Pitch torque tube end cap - replacement

| Classification - | Mandatory |
| Applicability | All Europa aircraft |

Fig 2. End cap with anchor nut.

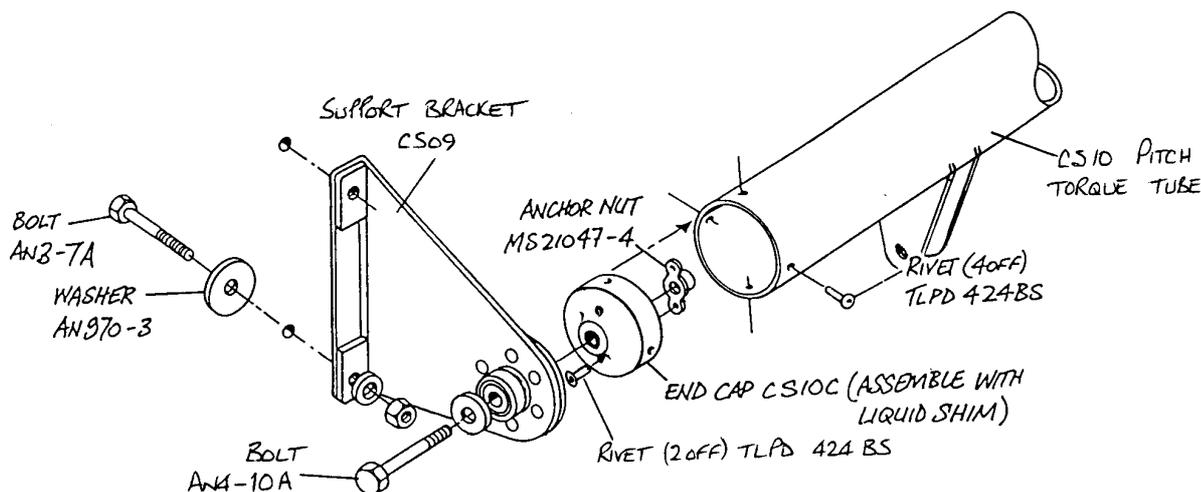
Drill the new end caps for the supplied MS21047-4 anchor nut, and open up the anchor nut mounting holes, with a 3.3 mm drill, and rivet the anchor nut as shown in figure 2. **Note the orientation of the anchor nut on the new cap, which is not the same as the original.**

Fig 4. New end cap installed in torque tube.

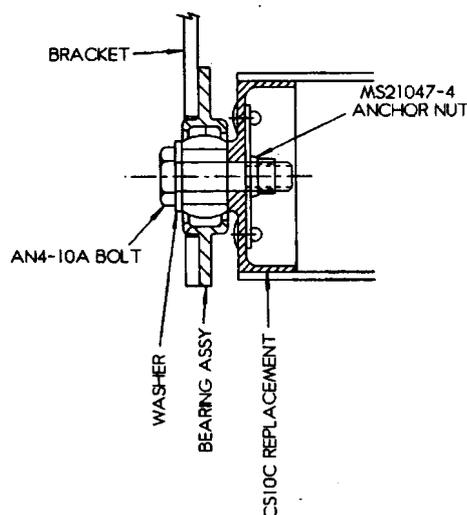
The EUR001 washer that was fitted between each original CS10C and self-aligning bearing is no longer used, and the new CS10C has a boss machined on it to take up the clearance created by removing the washer. Therefore when fitting the new end cap the base should be flush with the tube end, with the boss proud of the tube end. First restore any corrosion inhibiting in the inside of the tube.

Insert the end cap with the anchor nut attached into the end of the torque tube with rapid epoxy between the mating surfaces. The two end caps must be as square as possible to each other to minimize misalignment of the pivot bolts. Any remaining misalignment will be accommodated for by the self-aligning bearings that are mounted to the support brackets. The rapid epoxy is used as a liquid shim only in this application. See figure 4.
